Access Compliance Report

Public Rights-of-Way

(Curb Ramps)

Intersection ID: 29933	Main Street: CAROLINA_LILY_LN	Cross Street: APPLIEDALE_DR	Location: SE
ADA ID: EAEAB2F1D096	Ramp Type: BlendTrans1	Initial Pass/Fail: Fail	Overall Compliance: No
		Severity Score: 12.5

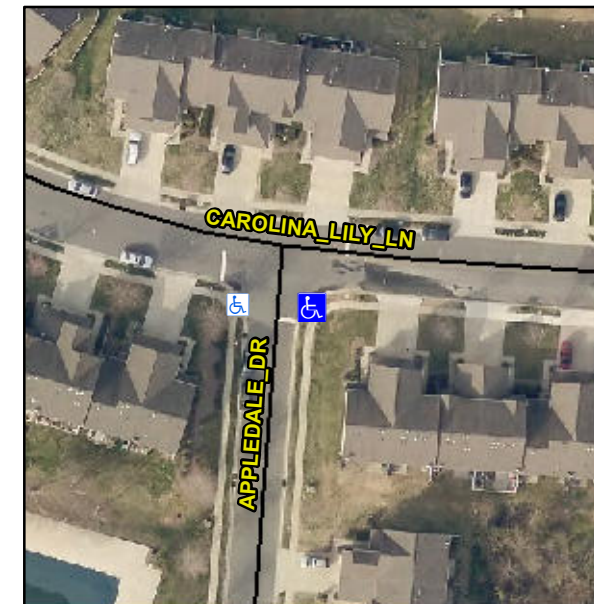
Not Found, R304.5.3

Compliance	Description	Data	Compliance	Description	Data
N/A	Ramp Length (in)	48.0	Yes	BlendTrans Slope (%)	3.0
Yes	Ramp Width (in)	126.0	No	BlendTrans XSlope (%)	5.7
N/A	Flare Type LT	N/A	N/A	Flare Type RT	N/A
N/A	Flare Slope LT (%)	N/A	N/A	Flare Slope RT (%)	N/A
N/A	Flare Traversable LT?	N/A	N/A	Flare Traversable RT?	N/A
N/A	Landing Length (in)	N/A	N/A	DWS Provided?	N/A
N/A	Landing Width (in)	N/A	N/A	DWS Contrast?	N/A
N/A	Landing Slope (%)	N/A	N/A	DWS Length (in)	N/A
N/A	Landing X Slope (%)	N/A	N/A	DWS Full Width?	N/A
N/A	Landing Curb? (Y/N)	N/A	N/A	DWS Offset (in)	N/A
N/A	Shared Landing?	N/A			
N/A	Gutter Ponding?	N/A	N/A	Gutter Slope (%)	N/A
N/A	Gutter Lip Ht (in)	N/A	N/A	Gutter X Slope (%)	N/A
N/A	Painted X Walk1?	No	N/A	Painted X Walk2?	No
	X Walk 1 Direction	To N		X Walk 2 Direction	To W
	X Walk 1 Width (in)	N/A		X Walk 2 Width (in)	N/A
	X Walk 1 Slope (%)	2.2		X Walk 2 Slope (%)	4.2
	X Walk 1 X Slope (%)	5.8		X Walk 2 X Slope (%)	4.0

N/A	Ramp inside XWalk1?	N/A	N/A	Ramp inside XWalk2?	N/A
	Road Slope (%)	5.1		Clear Space?	N/A
	Road X Slope (%)	0.0	N/A	Clear Space to XWalk (in)	N/A
N/A	Any Obstructions?	N/A	N/A	Storm Grate/Utility Hazard?	N/A
	Obstruction Type			Storm Grate/Utility Type	
		N/A			N/A
			Yes	Surface Condition? (G/P)	Good
			No	Curb Slope (%)	19.7

Remove & Replace Curb Ramp With Two New Directional Ramps or Equivalent.
